NHTSA Safety Recall 24V-826

SUBJECT: Campaign # 192 – Hood Mounting Bracket(s)

E & F Series Hood Bracket

Figure 1

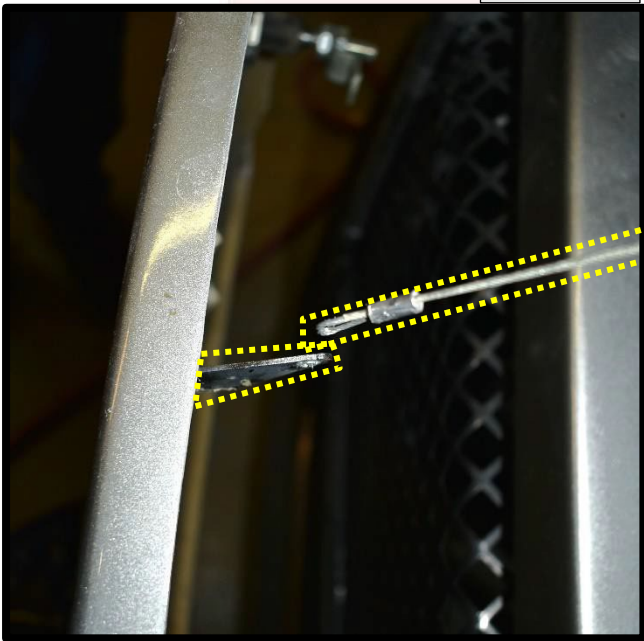
1. Remove the screw from the cable that attaches to the rear of the front hood. (See Figure 1- Yellow)
2. Remove the retaining clips (See Figure 2 – Yellow) from each side of the front hood to be able to remove the hood rod assembly from the mounting bracket. (See Figure 2 – Red). Once done, the whole front hood can be removed from the vehicle.

Figure 3

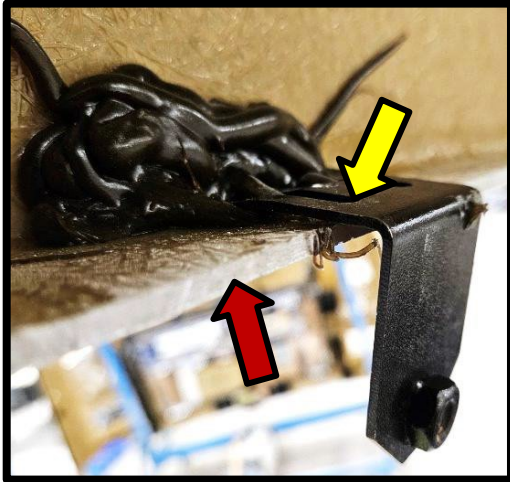
1. Follow the steps below for **all 8** critical brackets.
2. See Figure 3. Ensure that all 8 critical brackets (yellow arrow) are as flush as possible with the fiberglass lip around the hood cutout (red arrow). Brackets may need to be bent to bring the two surfaces closer together.

- a. When bending the brackets be careful not to apply excessive force to the fiberglass as it could crack.
3. Using a ½" wrench, remove the hood adjustment bolt and locking nut on the front side of the bracket from each of the 6 hood stop brackets. See Figure 4.

Figure 5

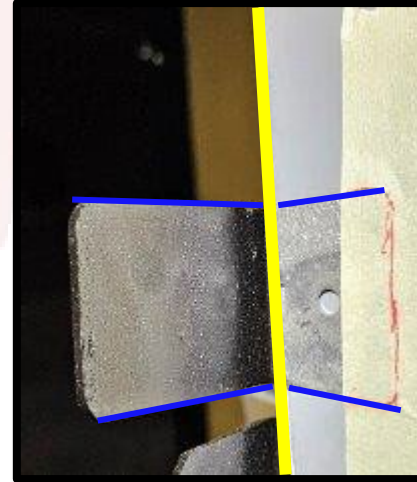
4. Using the provided drilling template, drill a hole through the fiberglass and bracket for each critical bracket.
 - a. Use the narrow edge with the notch for the hood latch brackets. See Figure 5.

- b. Use the wide edge without the notch for the hood stop brackets. See Figure 6.
 - c. Align the edge of the tool with the trimmed edge of the fiberglass. See Figures 5 and 6 Yellow Lines

- d. Align the sides of the tool with the sides of the bracket, the hole in the tool should line up with the center of the bracket. See Figures 5 and 6 - Blue Lines.

Figure 7

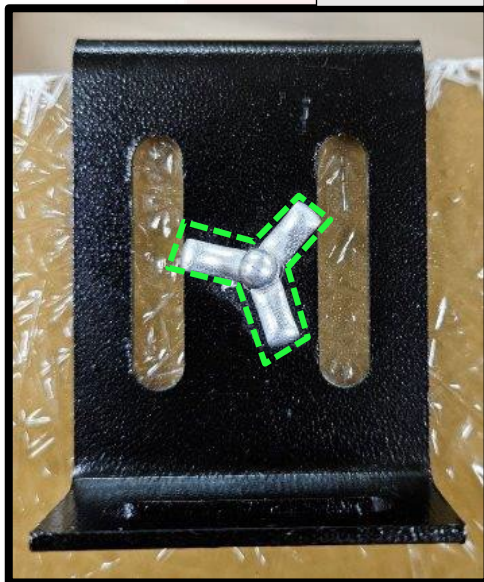
5. Note: Once the hole is drilled, check the backside to ensure the hole is roughly going through the center of the bracket, not through one of the existing slots in the bracket. If the rivet goes through the slot, its retention will be affected. See Figure 7 for proper rivet placement.

6. Install a rivet through the fiberglass and the bracket. This should leave the head of the rivet in the hood cutout.
 - a. Ensure the rivet is fully engaged and the mandrel is broken off. (See Figure 7 & 8)

Figure 9 – Front Hood Opening

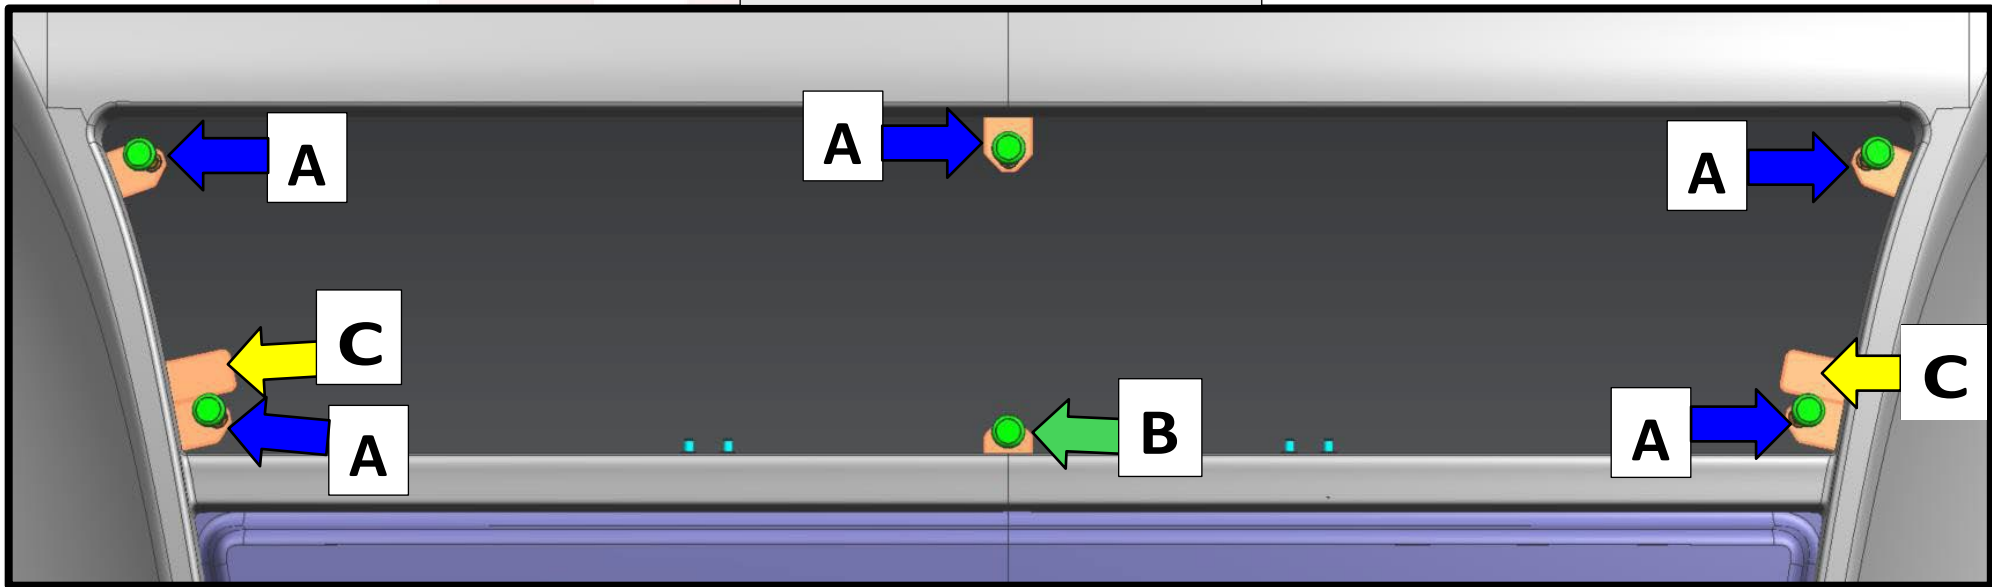
There are 8 critical brackets on the edges of the front cap.

- Total of 5 long hood stop brackets, 2 on either side and 1 on the center on the top. (See Figure 9 - Blue Arrows "A")
- Total of 1 short hood stop bracket, in the center on the bottom. (See Figure 9 - Green Arrow "B")
- Total of 2 hood latch brackets, 1 on either side. (See Figure 9 - Yellow Arrow "C")
